**TECHNICAL BULLETIN: 15-07
(Revised)**

SUBJECT: Release of Software Version 4.0 with Windows CE 6.0 operating system for ARGO 7, ARGO 12, FT5300, RL5300, RT2300, and RL2300 with 8" and 10.4 display. (Revised)

1. Initial Configuration Screen

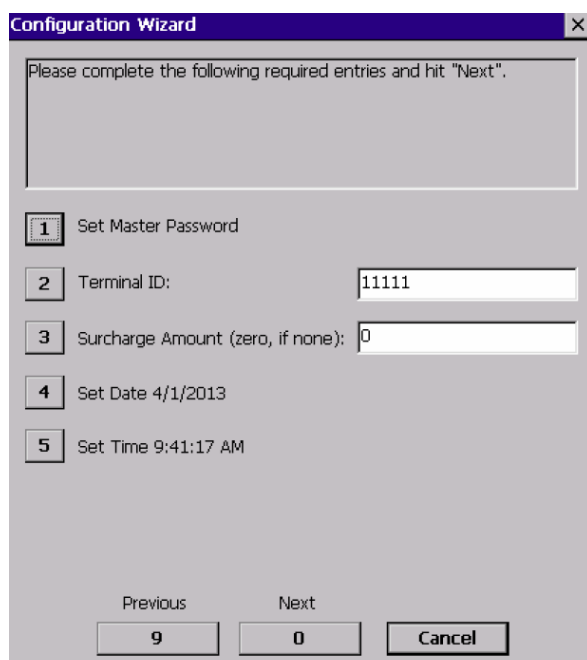
- **Configuration Wizard**

This software release contains a wizard type interface to step customers through the initial ATM Setup. The wizard includes the following steps:
